**Subject** WESTBARD: Regency's Development Plan

## **Comments on Regency Centers Preliminary Plan and Site Plan for the Westbard Redevelopment**

The Springfield Civic Association is hereby providing its initial comments on Regency Centers Preliminary Plan (Plan Number 120170170) and Site Plan (Plan Number 820180190) applications for the Westwood shopping center and adjacent areas.

***Comments on Regency Centers' Site Plan No. 820180190 (Shopping Center, Phase I) and Preliminary Plan No. 120170170 (Manor Care and Westwood II, Phase II)***

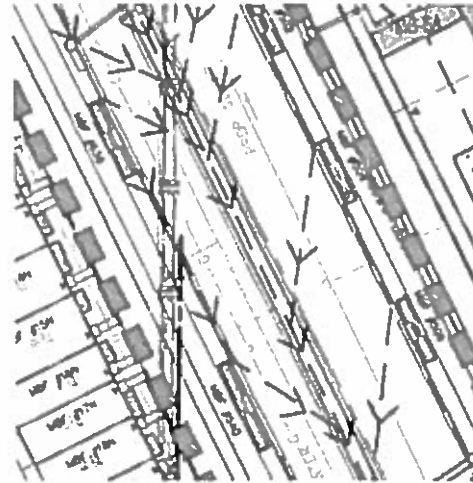
Regency Centers proposes to build the Westwood Shopping Center, a redevelopment project in Bethesda totaling 23 acres. For Preliminary Plan # 120170170, the Applicant proposes to construct up to 647,378 square feet of residential uses, and 176,232 square feet of new commercial uses. The table below lays out the stormwater volume numbers for the overall project stormwater management concept plan. The plan addresses the required stormwater volumes using a combination of green roofs; micro-bioretenion; and stormwater vaults, and requests a fee-in-lieu for Phase 2A for 82% of its required stormwater volume (Westbard Avenue). For Phase I, the proposed green roofs and micro-bioretenion are Environmental Site Design (ESD) practices (54% of ESD volume, or ESDv); the stormwater vaults are “structural” practices (46% of the ESD volume).

For Phase 2A (Westbard Avenue), only 18% of the ESDv would be treated by micro-bioretenion, with a fee-in-lieu requested for the remaining 9789 cubic feet; for Phase 2B, 64% of the ESDv would be treated by a green

Figure 2.4.7: Westbard Business - Private Street Section  
 Local Street ( On the Westwood Shopping Center Site)  
 Proposed Section

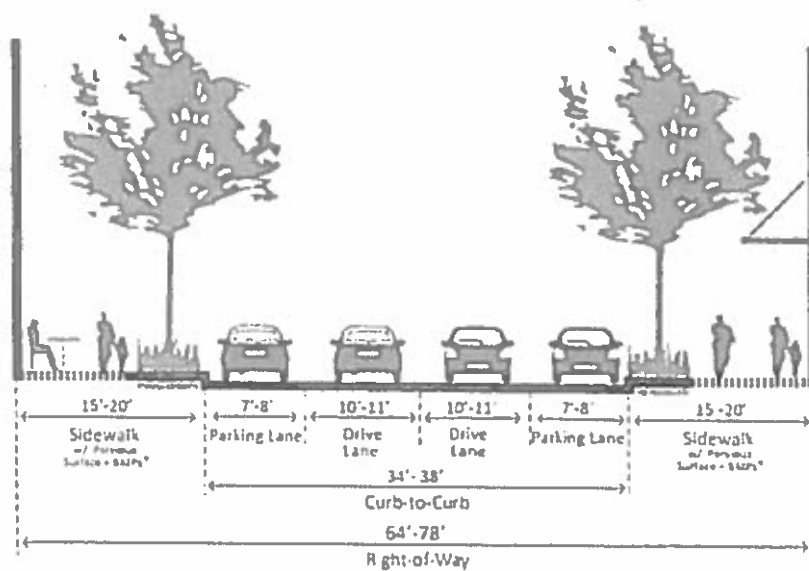
\* To be further studied: Potential best management practices in curb extensions and sidewalks as well as pervious surfaces on sidewalks
